AERONAUTICAL CHARTING FORUM
Instrument Procedures Group
Meeting 15-01 – April 28, 2015

RECOMMENDATION DOCUMENT

FAA Control # 15-01-321

Subject: Coding of Missed Approach for ILS31L and ILS31R at KJFK

ILS or LOC RWY 31L **JOHN F KENNEDY INTL (JFK)**

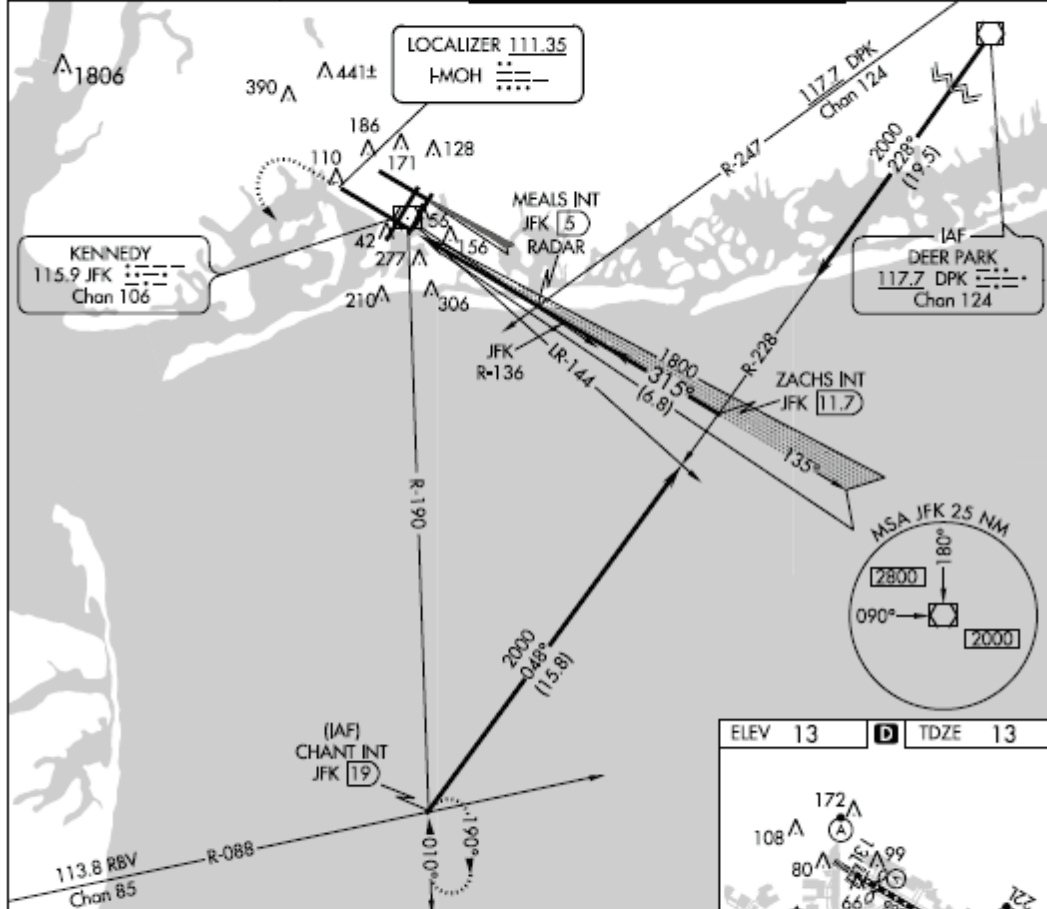
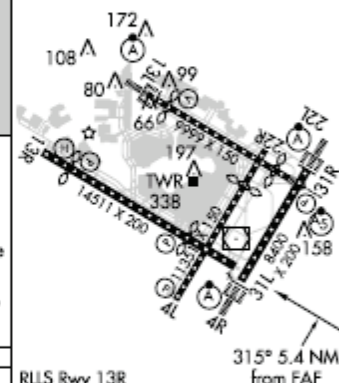
Background/Discussion: It was recently discovered by an airline crew that the missed approach for the ILS31L and ILS31R at KJFK does not appear to be coded correctly in the FMS database. The coding and text on the approach chart do not match and is causing confusion in the cockpit. The FMS coding indicates these are “At or Above” altitudes, however the text indicates the intent of these to be coded as “At” altitudes. It seems that the “at” altitude is indeed providing procedural separation the way it is described. Investigation with Aeronautical Information Services (AIS) and Jeppesen revealed that the text description indicates a level off, but the actual coding indicates “at/above or minimum.” FAA Form 8260-3 states that “Altitudes are minimum altitudes unless otherwise indicated.” However, when it comes to the text used to describe missed approach instructions, Order 8260.19F, paragraph 8-6-7d Note, states:

MISSED APPROACH: Climb to 500 then climbing left turn to 1000 until intercepting JFK R-190, then climb to 3000 via JFK R-190 to CHANT INT/JFK 19 DME and hold.

Recommendations: Unlike RNAV procedures that are accompanied with ARINC coding information with the procedure, non-RNAV procedures do not. Recommend that database coding authorities become familiar with and comply with the use of the terms (i.e., “and” vs. “then”) used when coding conventional instrument procedures as defined in Order 8260.19F, paragraph 8-6-7d Note.

NEW YORK, NY
ILS or LOC Rwy 31R

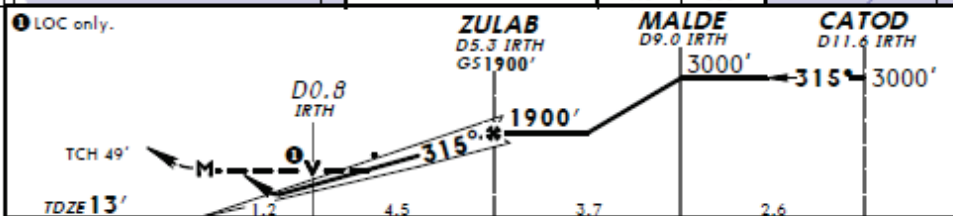
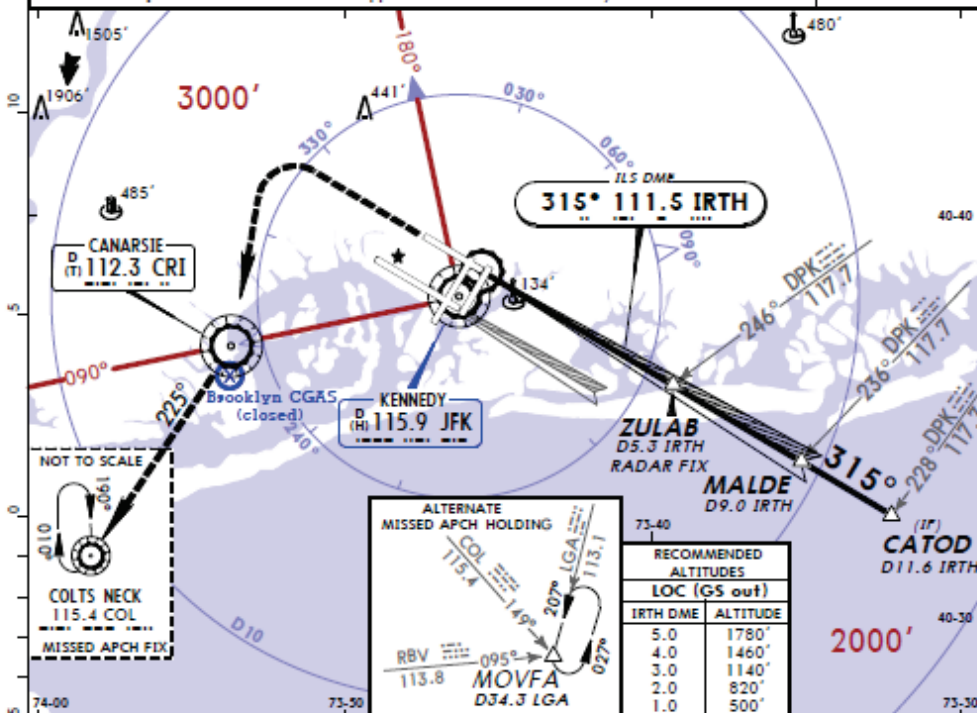
MISSED APCH: Climb to 1800' then climbing LEFT turn to 2000' direct CRI VOR then climb to 4000' outbound via CRI VOR R-225 to COL VOR and hold, or as directed by ATC.
